Boston Alternative Energy Facility

Appendix E2 to Natural England's Deadline 2 Submission

**Further Natural England Advice in Relation to the Alignment of the England Coast
Path (ECP)**

Planning Inspectorate Reference: EN010095

Figure 1: Natural England's suggested ECP alignment.

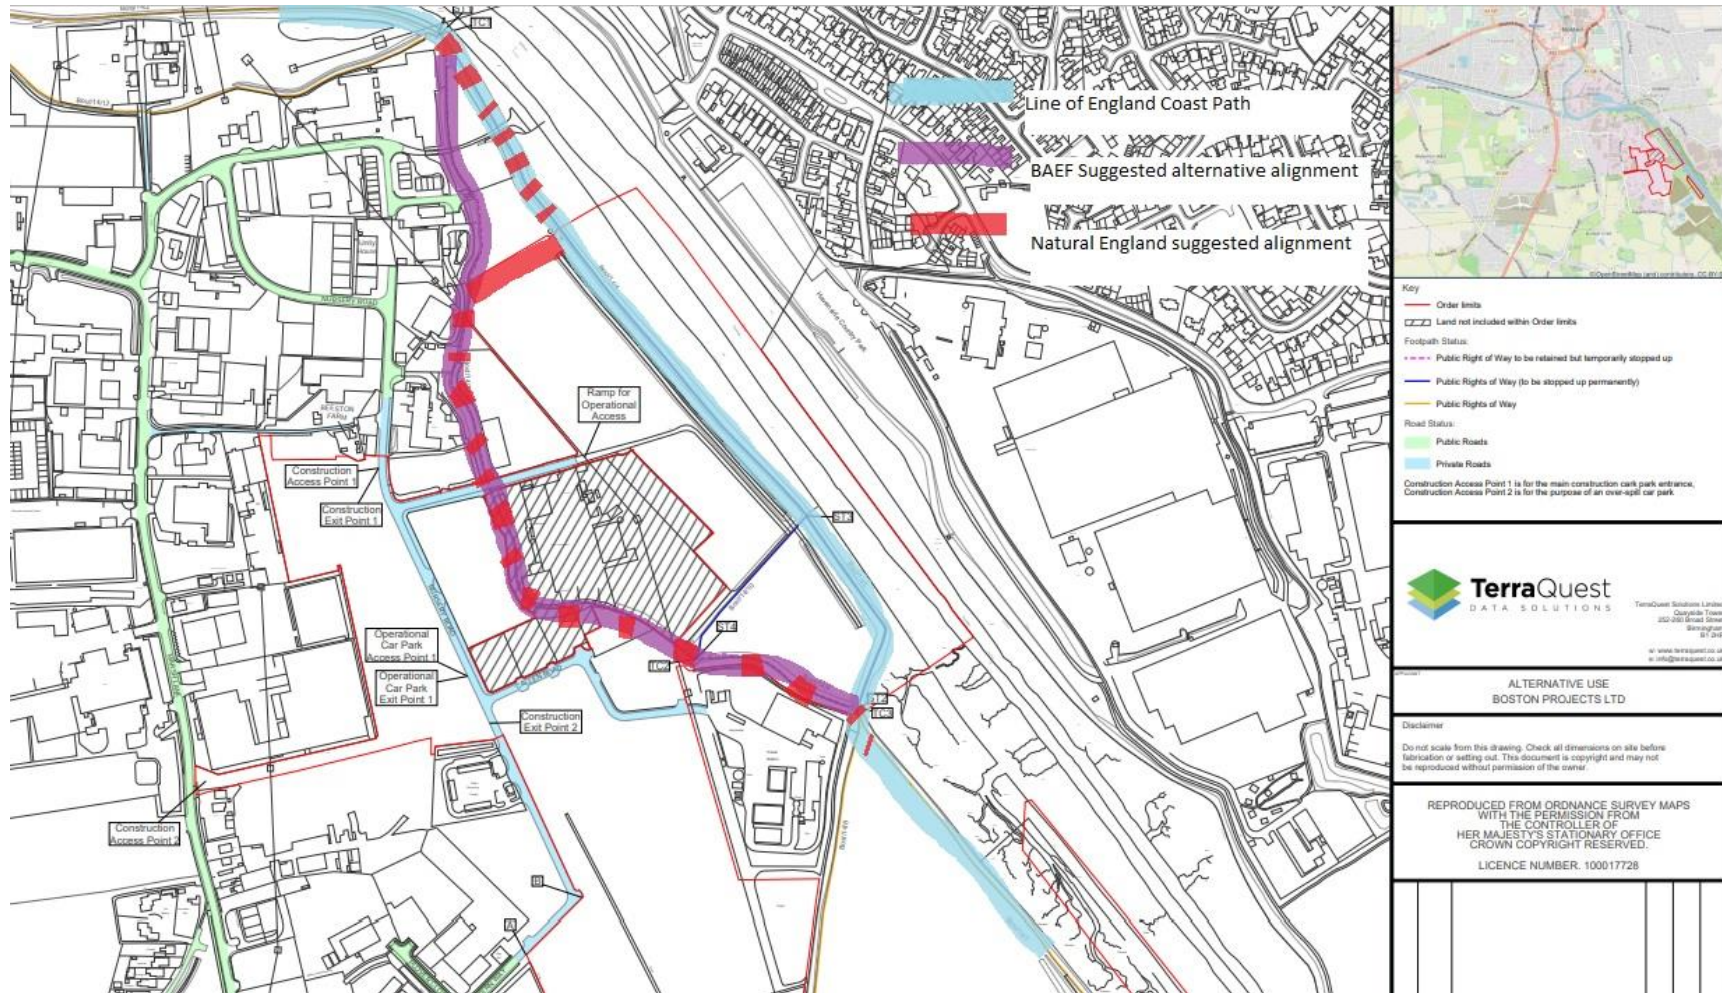
Contrary to Section 5.3.29 of the Environmental Statement, **Natural England doesn't support the Applicant's proposed new alignment of the ECP**. Natural England advise that the proposed new alignment unnecessarily constrains access to the coast which is contrary to the ECP legislation as designated by parliament.

Natural England therefore advises that alternative options such as that proposed in **Figure 1** below should be fully explored and assessed by the Applicant.

*NB: The red line on the site boundary, can be either side of the boundary and it doesn't have to be within any security fencing/site boundary and can readily be on adjacent land.
